UNITED STATES PATENT AND TRADEMARK OFFICE

APPLICATION NO.	FILING DATE	FIRST NAMED INVENTOR	ATTORNEY DOCKET NO.	CONFIRMATION NO.
10/812,148	03/29/2004	Gary W. James	METZ 2 00011	2979

Office Action Summary	Application No. 10/812,148	Applicant(s) JAMES ET AL.	
	Examiner Philip Gabler	Art Unit 3637

DETAILED ACTION

Exhibit 1: Evans '365 Figures 3-5

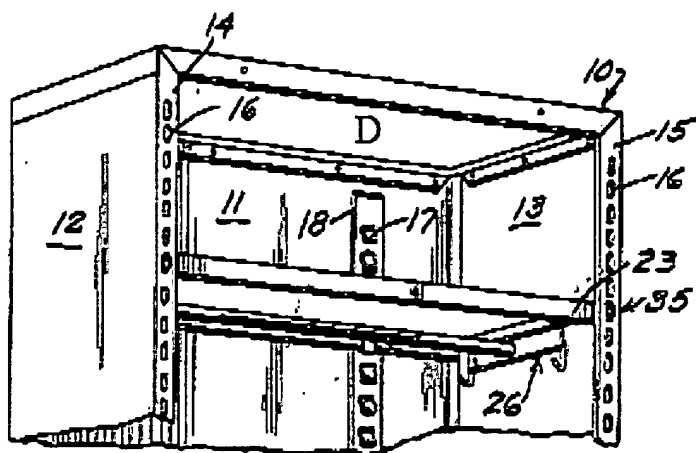
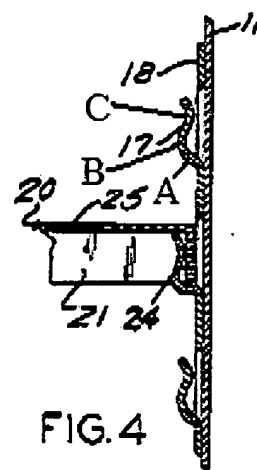
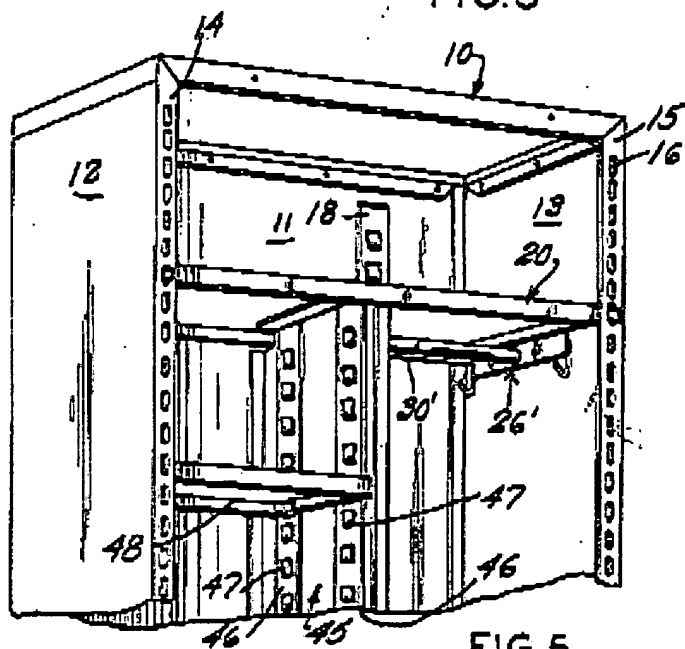
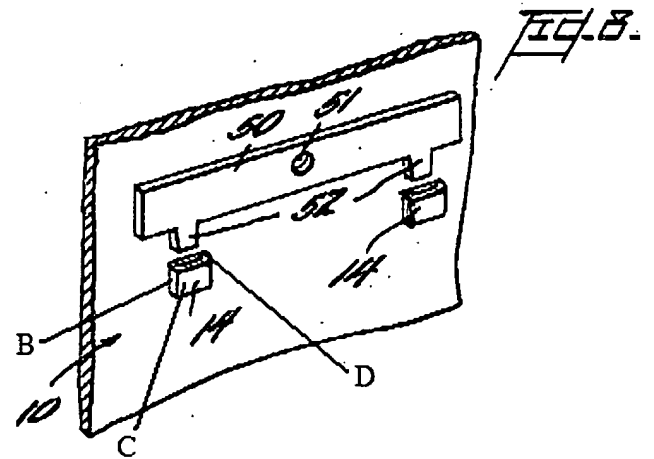
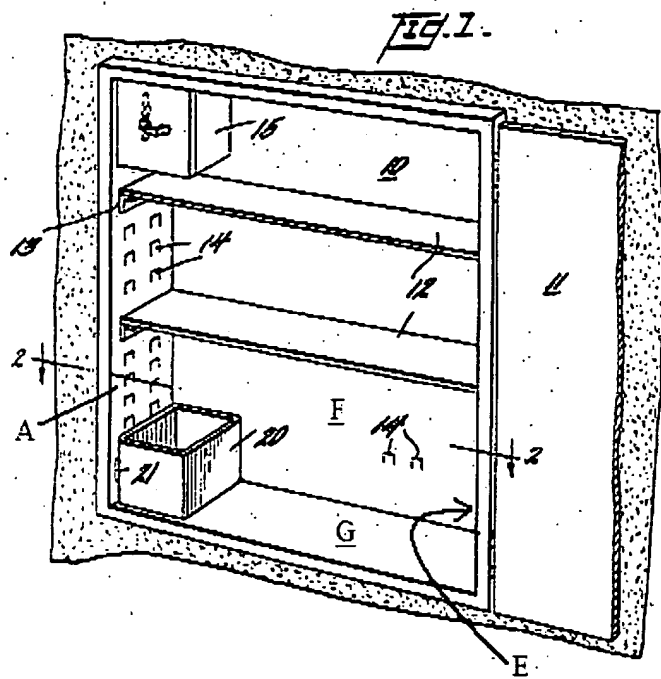
8. Regarding claims 1 and 17 Evans (Figures 3-5) discloses a cabinet comprising: a first side wall (12); a first support member (47), wherein the support member includes a first leg (viewed as A in Exhibit 1, note that legs of support members are shown best in Figure 4 of element 17, which is equivalent to 47) extending at least substantially normal to the first side wall and a second leg (B) extending from the first leg spaced from and at least substantially parallel to the first side wall; a second side wall (13) positioned opposite the first side wall; a third wall (11) interconnecting the first and second side walls; a base wall (not shown, but inherent in a cabinet structure, located opposite top surface D) interconnecting the first, second and third walls, and a second support member (17) extending from the third wall, the second support member is positioned at substantially the same height from the base wall as the first support member on the first wall, the second support member includes a first leg extending at least substantially perpendicular to the second side wall and a second leg extending from the first leg spaced from and at least substantially parallel to the second side wall; and a removable shelf (20) including a planar surface and a first flange (21) depending from the planar surface, and the shelf includes a second flange (24) depending from the planar surface. Evans discloses an alternate support member on the first and second side walls and does not disclose support members punched through walls, or hemispherical dimples or openings in shelf flanges to receive them. Wise (Figures 1

9. Regarding claim 6, Evans further discloses the support member is a lance.

11. Regarding claims 14 and 18, Evans further discloses a support wall (45) disposed between the first side wall and the second side wall in a first direction and the removable shelf and the base wall in a second direction.

12. Regarding claims 15, 16, 19, and 20, Evans does not specifically disclose a connection for the support wall to the base wall and removable shelf. However, he does disclose the use of lances for connecting elements (support wall to shelf 48 for instance) and it accordingly would have been obvious to one of ordinary skill in the art at the time the invention was made to use a lance connection for connecting the support wall to the base wall and removable shelf.

Wise '275 Figures 1 and 8

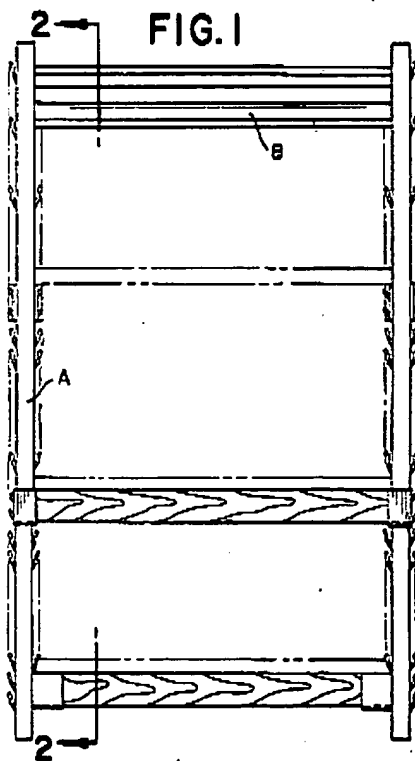
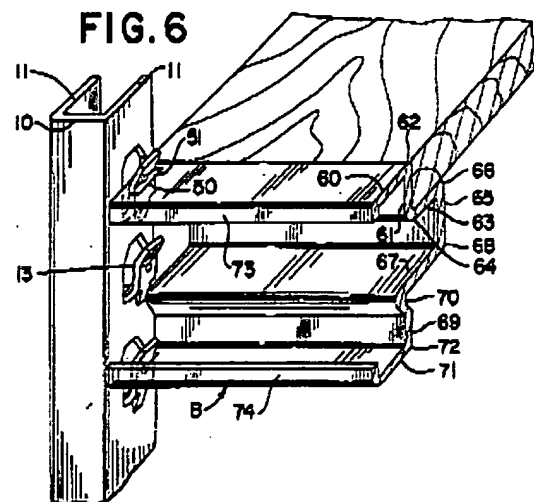
and 8) discloses support members (14) punched out of opposite side walls such that an opening (behind 14) is formed through a side wall. Accordingly, it would have been obvious to one of ordinary skill in the art at the time the invention was made to punch the Evans' support members directly from the walls as taught by Wise rather than adding a separate support member containing strip because this would reduce the number of parts and the complexity of manufacture of the cabinet. Vargo (Figures 1, 4, and 6) discloses a shelving system including support members (13) on opposite side walls for supporting opposite sides of a shelf and having first (at 20, 40) and second (23) legs, the second leg including a substantially hemispherical dimple (36) for mating with an opening (50) in a flange (B) of a shelf. Accordingly, it would have been obvious to one of ordinary skill in the art at the time the invention was made to include dimples and receiving openings as taught by Vargo in Evans' support members because this arrangement would help prevent accidental removal of the shelves. It further would have been obvious to one of ordinary skill in the art at the time the invention was made to include similar support members (with first and second legs, and dimples) on the side walls of Evans' cabinet as taught by Vargo because this would ease manufacture by allowing a single type of support member to be used throughout the cabinet as opposed to Evans' alternate side supports.

Vargo '638 Figures 4 and 6

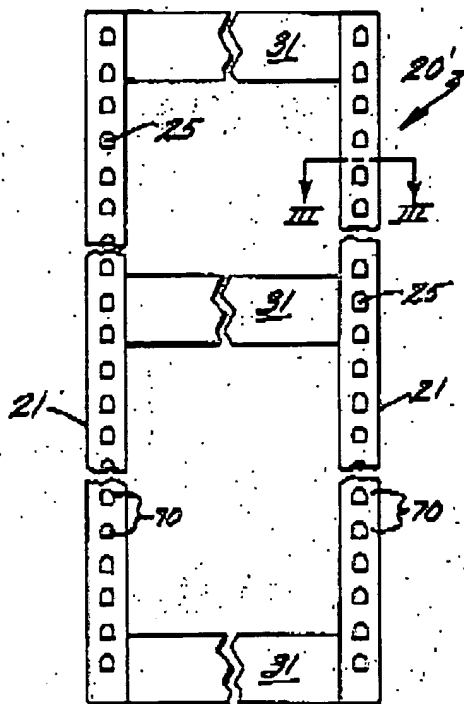
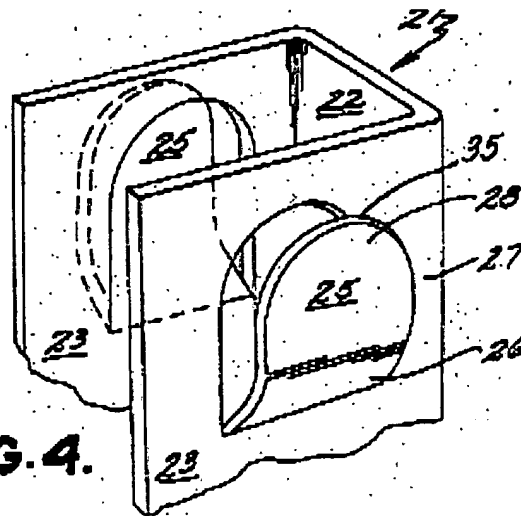
13. Regarding claim 21, Evans, as modified by Wise and Vargo as described above, discloses a third support member punched out of and extending from the third wall such that a third opening is formed through the third wall adjacent the third support member, the third support member is positioned at substantially the same height from the base wall as the first support member on the first wall, the third support member includes a first leg extending at least substantially perpendicular to the third wall and a second leg extending from the first leg spaced from and at least substantially parallel to the third wall, the second leg of the third support member includes a substantially hemispherical dimple, and the removable shelf further including a flange depending from the planar surface including an opening dimensioned to receive the dimple of the third support member.

15. Claim 10 is rejected under 35 U.S.C. 103(a) as being unpatentable over Young in view of Vargo. Young discloses a lance formed in a side wall of a cabinet for supporting a removable shelf, the lance comprising: a first leg (26) extending at least substantially normal to an associated surface (note that Young discloses an acute angle between the first leg and the surface 27, but based on his figures, the leg is viewed as substantially normal); a second leg (28) extending from the first leg at least substantially normal to the first leg, the second leg including a round upper edge. Young does not disclose a substantially hemispherical dimple formed in the second leg. Vargo discloses a shelving system including lances (13) for supporting opposite sides of a shelf and having first (at 20, 40) and second (23) legs, the second leg including a substantially hemispherical dimple (36) for mating with an opening (50) in a flange (B) of a shelf. Accordingly, it would have been obvious to one of ordinary skill in the art at the time the

invention was made to include dimples as taught by Vargo in Young's lance because this arrangement would help prevent accidental removal of a removable shelf.
